123 SHERMAN AVENUE PALO ALTO, CA

ARB AD HOC COMMITTEE MEETING PRESENTATION

09/22/2023

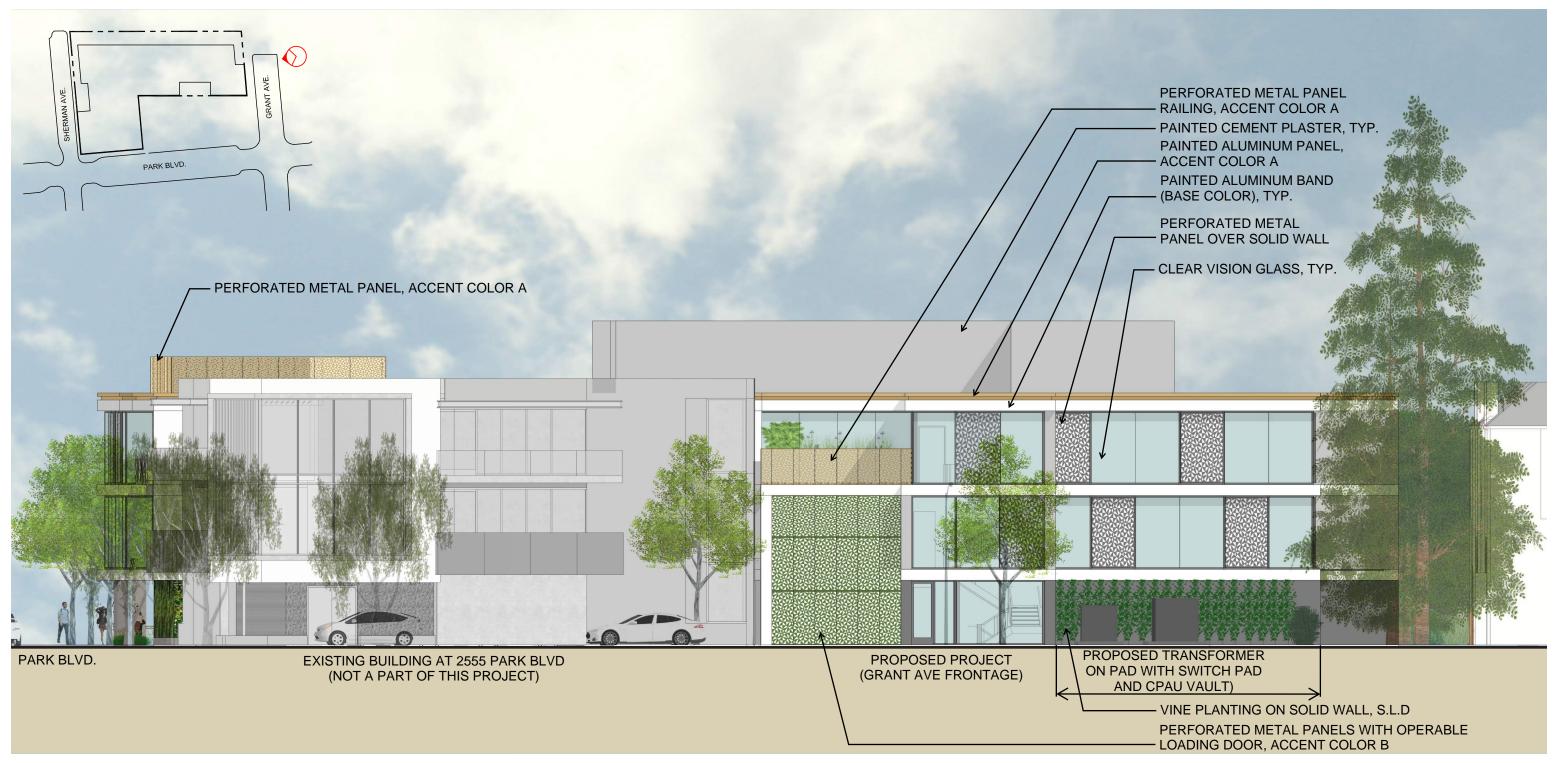
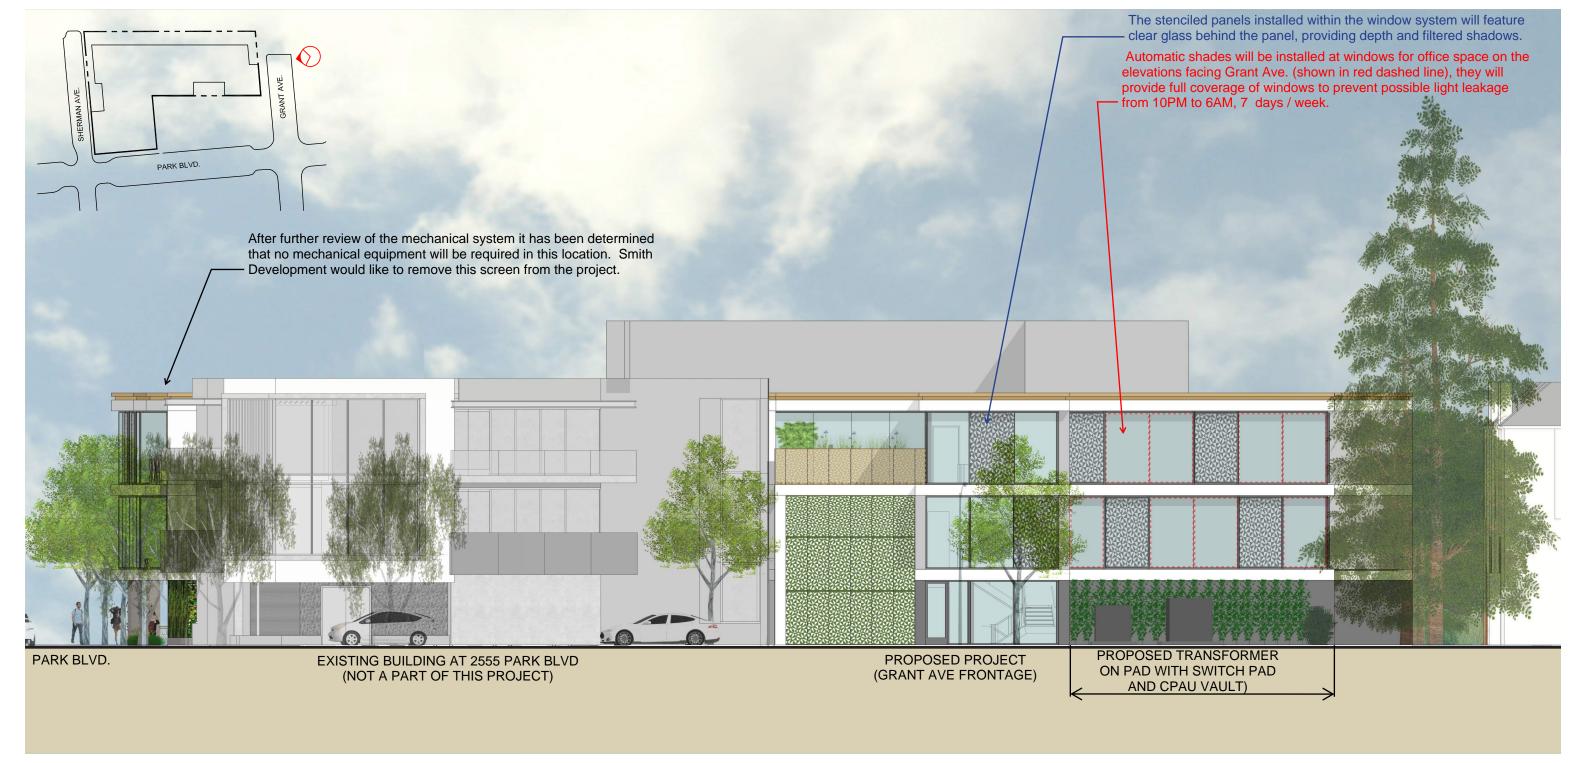
- Add additional screens to windows (with glass)
- Add automatic shades to the windows, on sides facing residences

- Response: All of the stenciled panels installed within the window system will feature clear glass behind the panel, providing C. depth and filtered shadows. Please refer to pages 15, 16, 18, 20, 21 and 23
- Response: Automatic shades will be installed at windows on the elevations facing the residences on the north elevation, Grant and Sherman Ave. They will provide full coverage of windows to prevent possible light leakage from 10PM to 6AM, 7 days / week. Please refer to pages 20, 21 and 23.

Study adding as much height as possible to the ground level

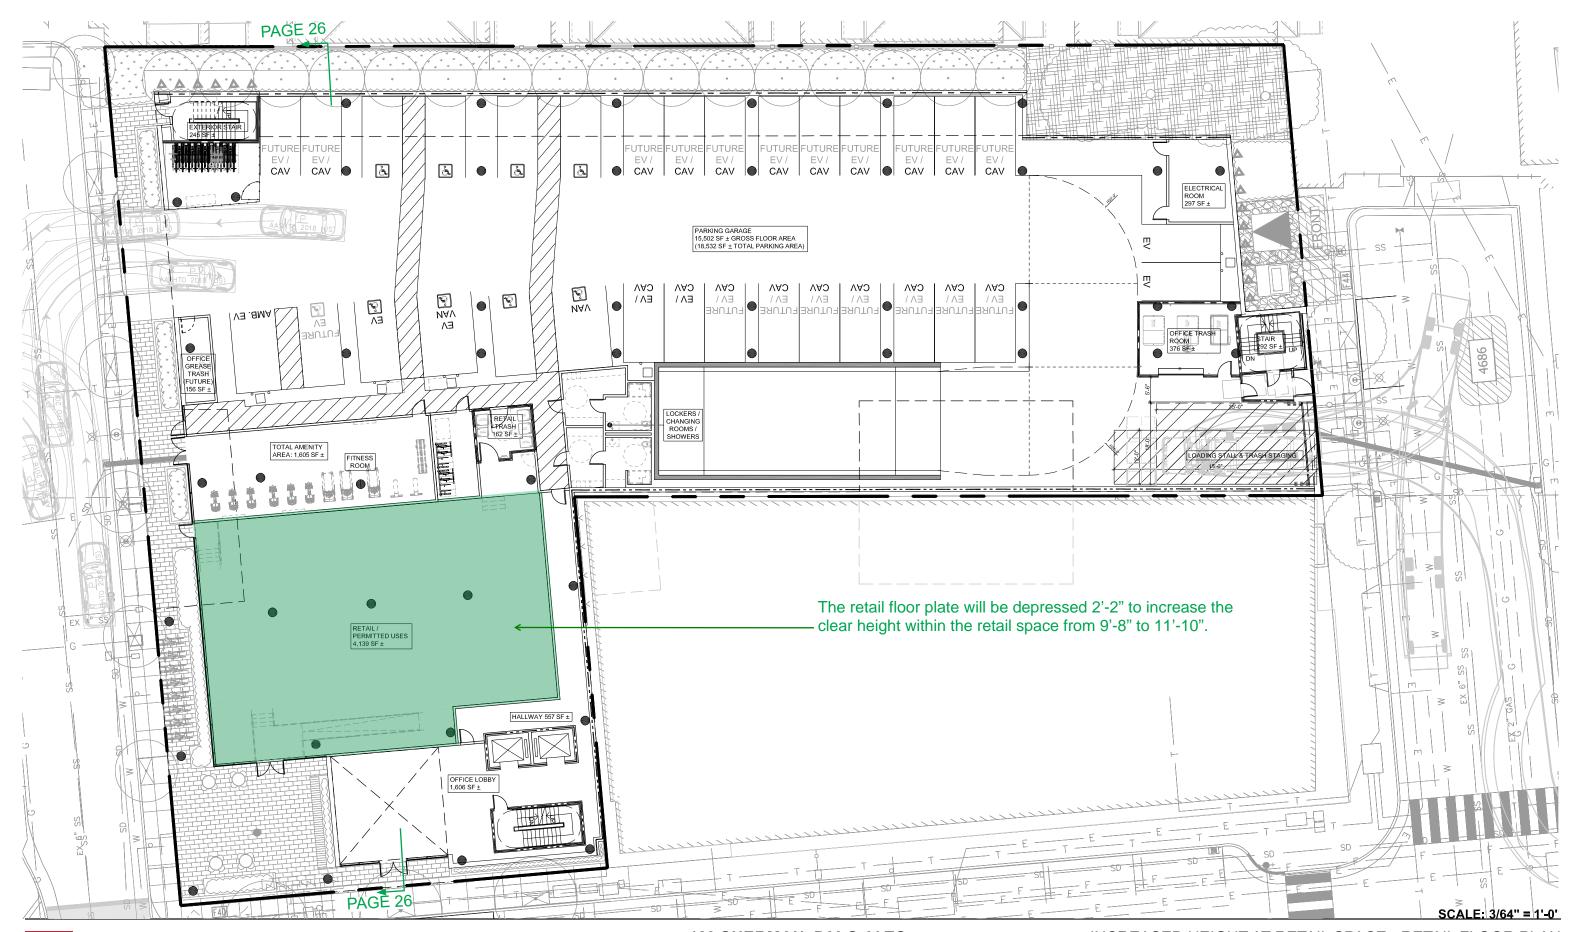
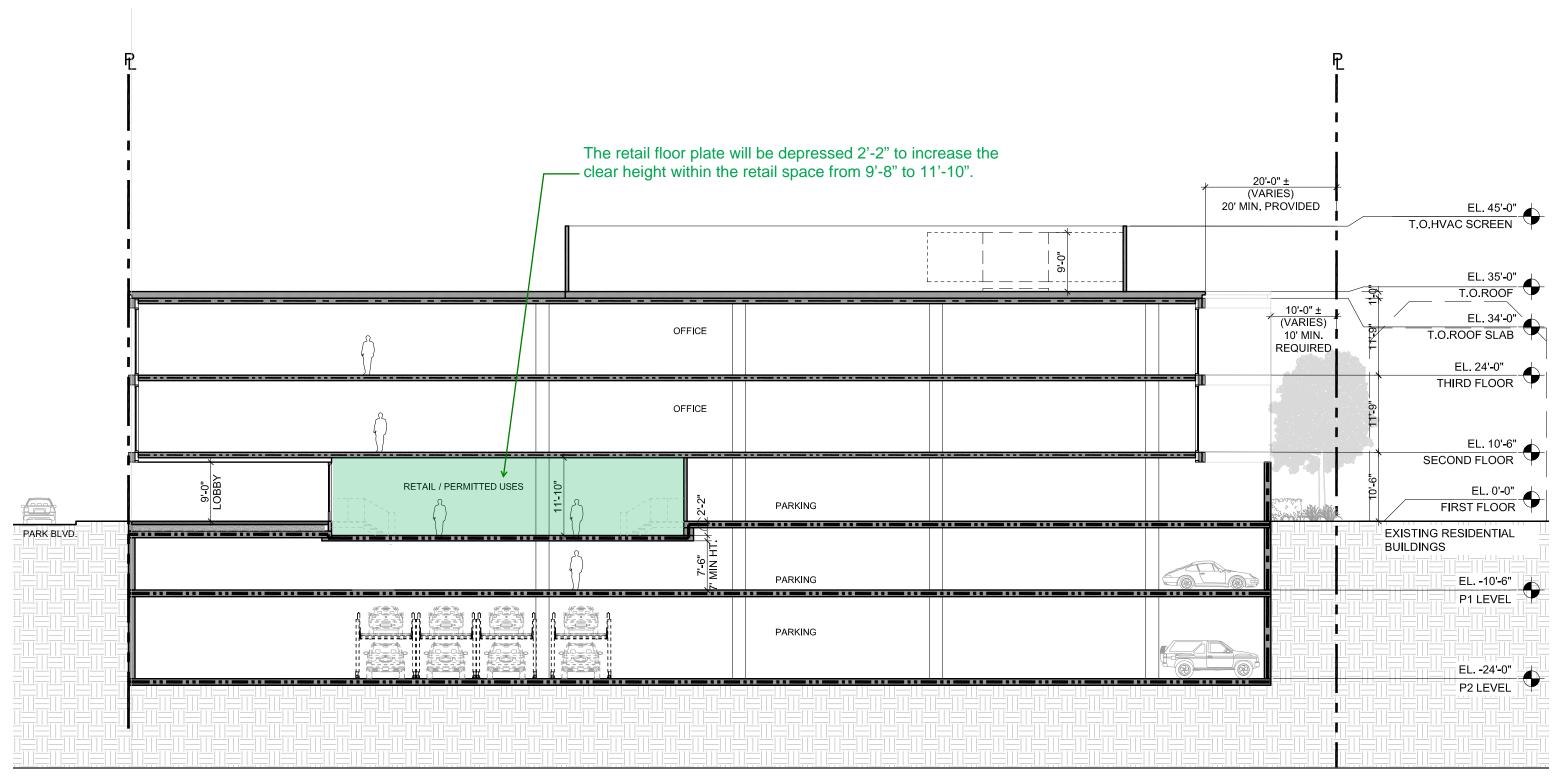
e. Study adding as much height as possible to the ground level

The retail floor plate will be depressed 2'-2" to increase the clear height within the retail space from 9'-8" to 11'-10". Please refer to pages 24, 25 and 26
